ENGINEERING CHANGE REQUEST (ECR)

CUSTOMER DRAWING NO. D972501

DRAWING TITLE HAM TOP ASSY

REVISION: FROM DI TO A

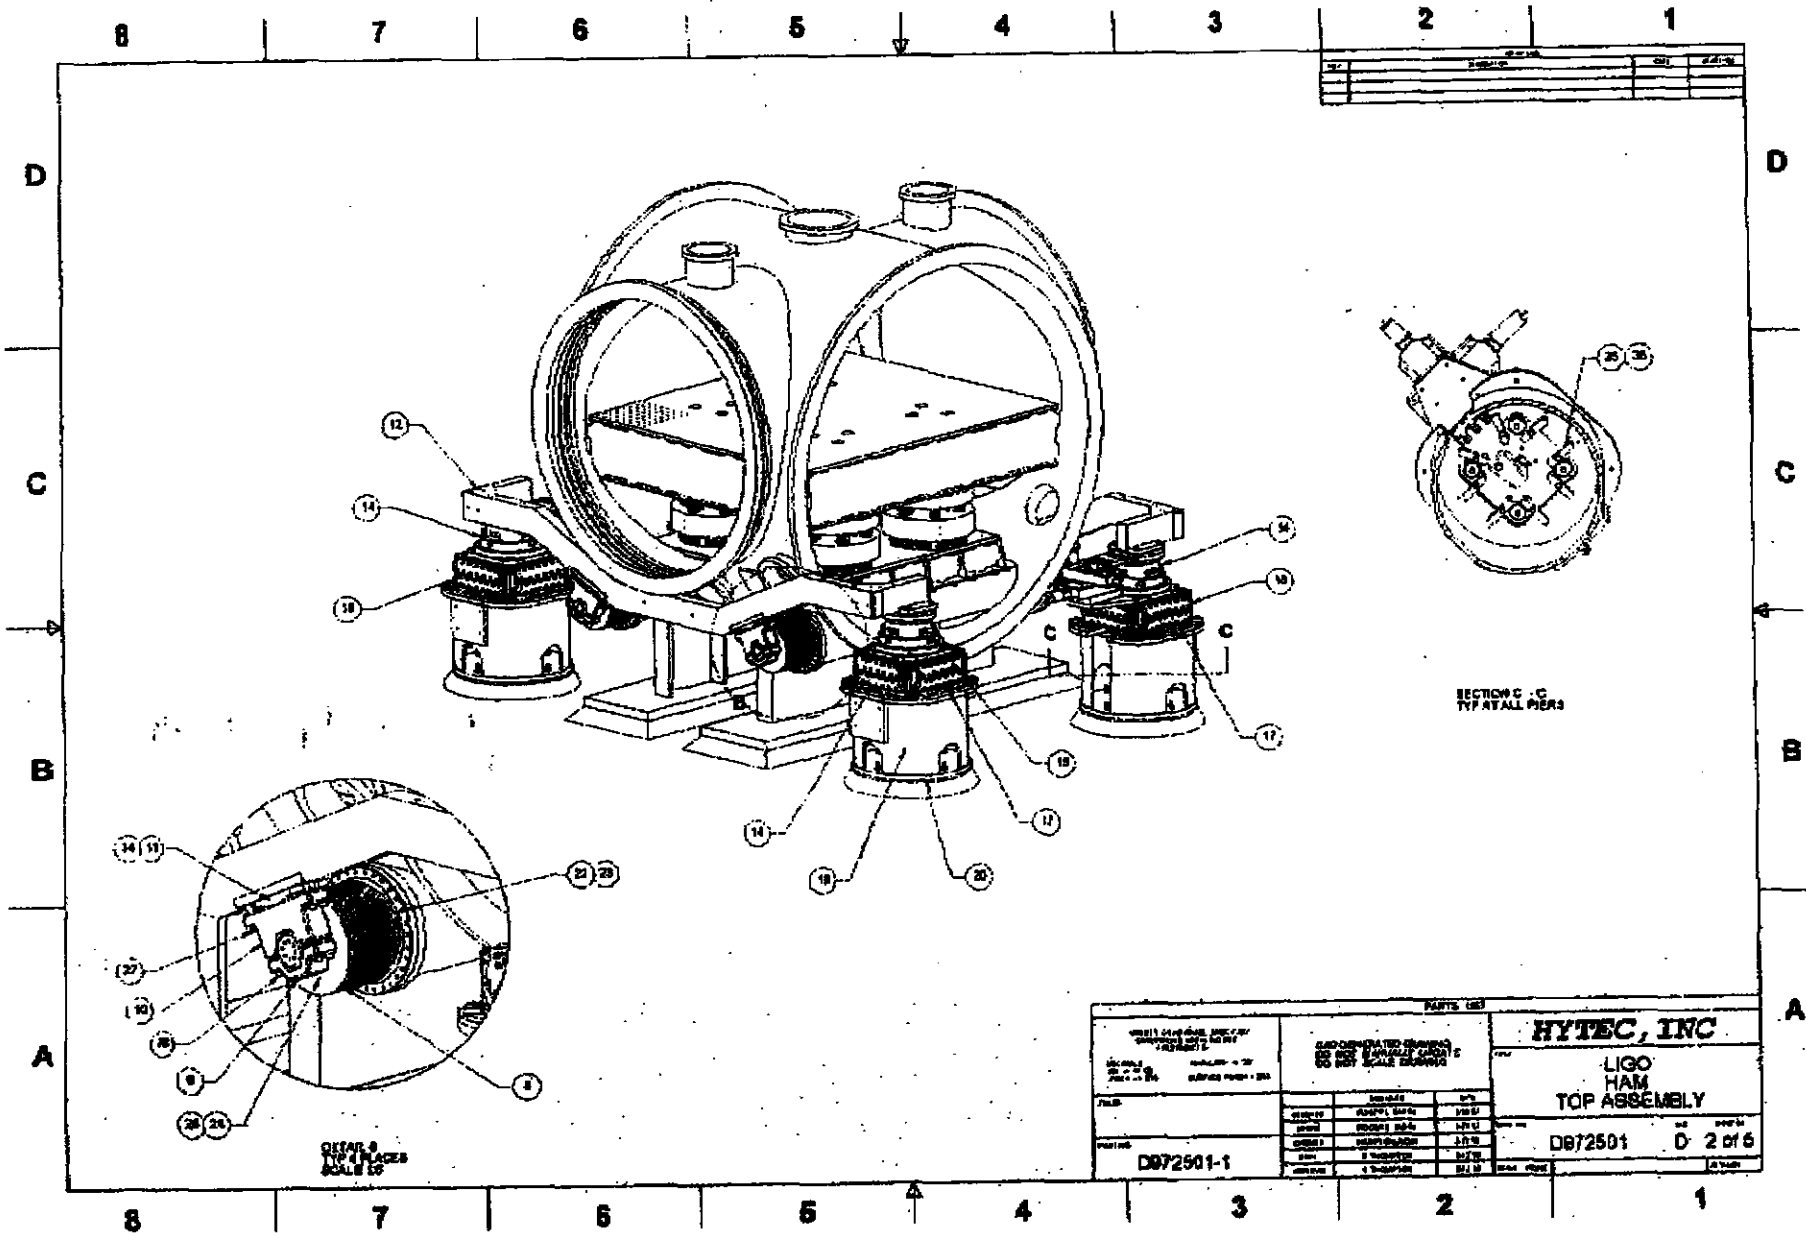
① SH 2 ZONE 78A; ADD SPHERICAL WASHERS TO
ITEM 37 QO.

② IN P/L: ADD MCMASTER PN 91944A470 1/2" SPH. WASHERS
QTY: 16

① & ② ALLOW ROTATION OF V-BLOCKS
